ARENA PARKING DESIGN CRITERIA
For Parking Structures Providing Shared Use Parking for Arena Events

Exhibit K

Re: **SSE Initial Comments on Documents for City Council Hearing of May 25, 2021
Downtown West Mixed-Use Project**

Figure 2

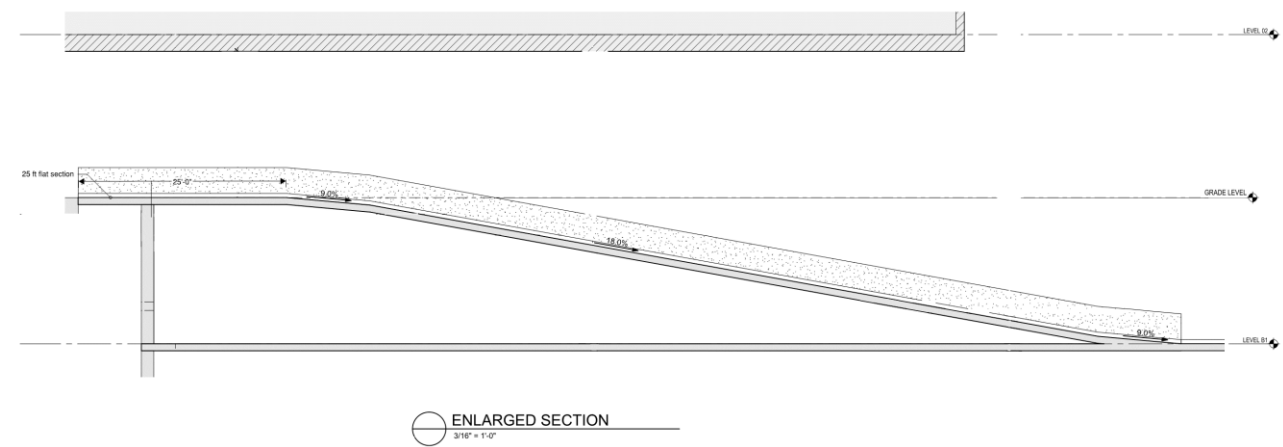
include a flat section at the top of approximately 25 ft. before using an internal ramp slope, which design has been approved by the City on other projects (**see attached Figure 2**). Internal ramps should be designed with an 18% maximum slope with 9-10% blends at the top and bottom.

Figure 2

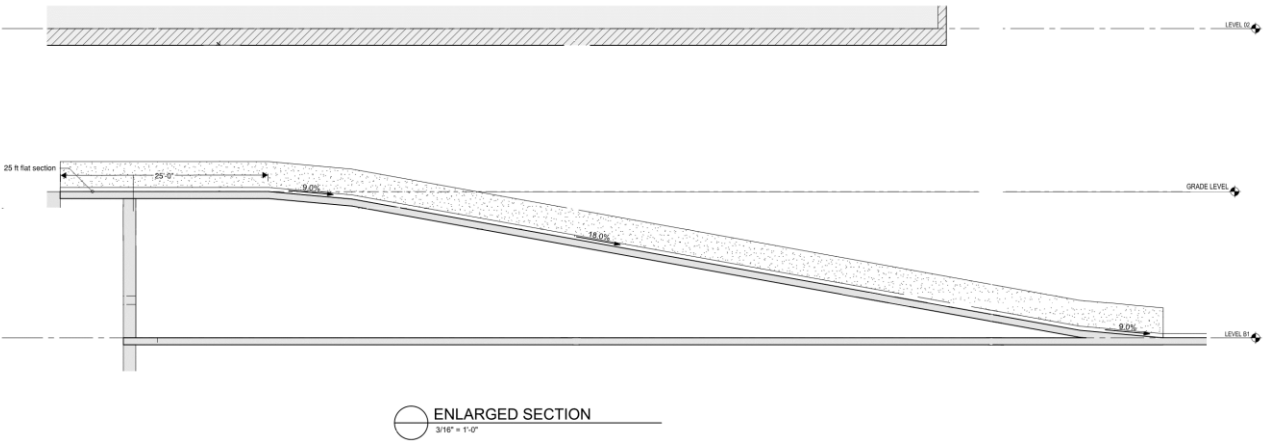
include a flat section at the top of approximately 25 ft. before using an internal ramp slope, which design has been approved by the City on other projects (**see attached Figure 2**). Internal ramps should be designed with an 18% maximum slope with 9-10% blends at the top and bottom.
